Record of Letter Ballot Review by TC Chapter for Procedural Review

Document Number	Document Title
6311A	New Standard: SPECIFICATION FOR TEM LAMELLA CARRIERS USED IN ELECTRON MICROSCOPY WORKFLOWS

Figure 1
Drawing of Grid Lamella Carrier as Viewed from Front Face

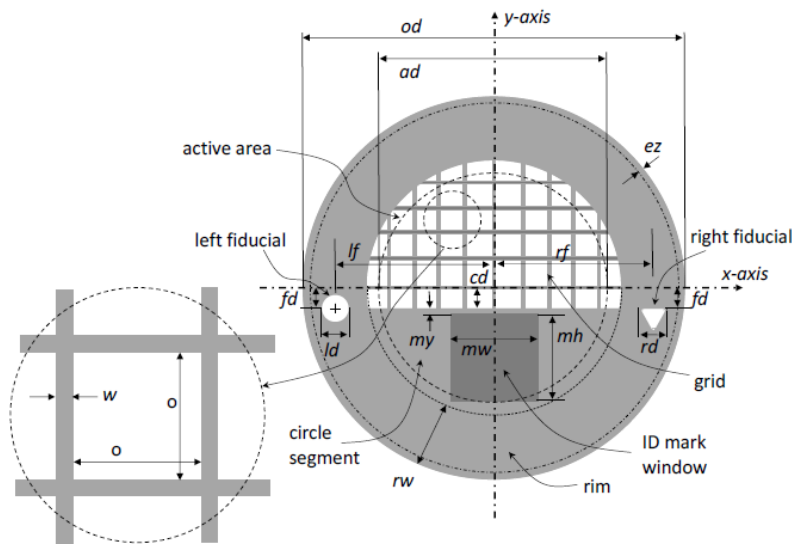
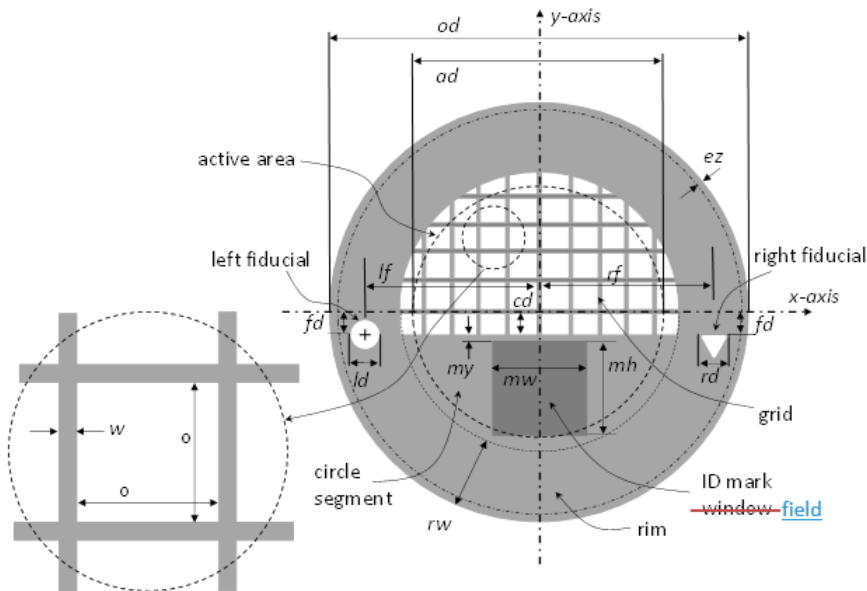
<table>
<tr>
<td rowspan="2">Comment</td>
<td colspan="2">*TF/TC Chapter to fill in section/paragraph #, if necessary.</td>
</tr>
<tr>
<td colspan="2">
2-7. ID MARKING
2-7.1	Type	~~2-dim square DMC~~ Data Matrix (2D code)	ISO16022
2-7.3	Position	Distance from Chord: 25 μm	by mutual agreement
2-7.4	Face for ID Mark	(specify): Front Face [ ], Rear Face [ ]	by mutual agreement
2-7.5	~~Dimensions of ID Mark Window~~ Exclusion zone for ID Mark	Width = 680 μm Height = 680 μm	~~by mutual agreement~~
2-7.6	Side Length of Square Dot#3,#4	Target [ ] ± Tolerance [ ] μm	by mutual agreement
2-7.7	Dot Depth #3,#4	Target [ ] ± Tolerance [ ] μm	by mutual agreement
2-7.8	Marking Quality#4	Better than grade C according to ISO 29158	ISO 29158
~~2-7.9~~	~~Content of ID Mark~~	~~(specify according to ISO 16022, ECC200):~~	
#3 Target values aiming at a Mark Grade better than C according to ISO 29158
#4 Specify either according to lines 2-7.6 and 2-7.7 or according to line 2-7.8
</td>
</tr>
</table>

Action	colspan	The TC Chapter agreed to do one of the following actions. Taskforce Recommendation (unanimous hand vote) Line 2-7.5: Change from 'Dimension of ID mark 'window' to 'field'

Justification (If necessary) Change from 'Dimension of ID mark 'window' to 'field' throughout the document. "Mark Field" is defined in the COT.

Motion	To approve above editorial change(s) And to not to follow the comments with the exception of the editorial change of the term "ID Mark Window" to "ID Mark Field". Change from 'Dimension of ID mark 'window' to 'field' throughout the document.
Motion by/2nd by	Peter Wagner (Self) / Larry Hartsough (UA Associates)
Discussion	"Mark Field" is defined in the COT. Figures 1 and 4 also need to be changed.
Vote	10 **Y**-0 **N**; Motion passed.
